REMARKS

Appln. No. 10/630,980
Amdt. dated June 30, 2004
Reply to Office Action of April 5, 2004
ANNOTATED SHEET SHOWING CHANGES

FIG. 4

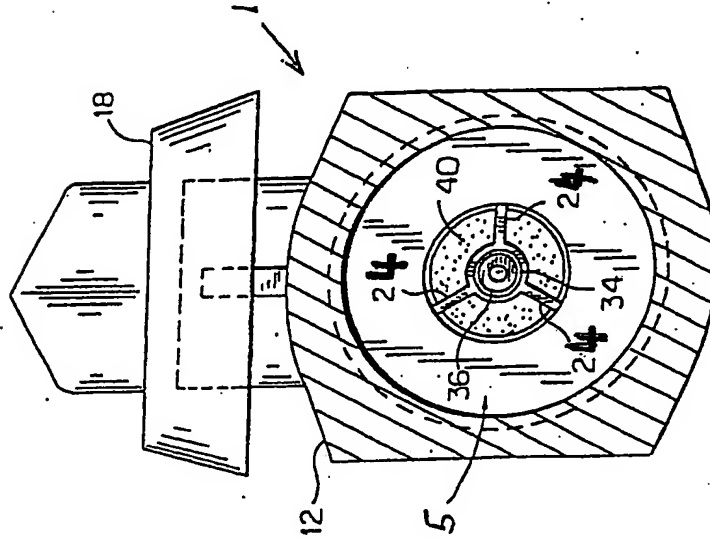
Applicant has included amended Fig. 4 to correct identification of struts (24).
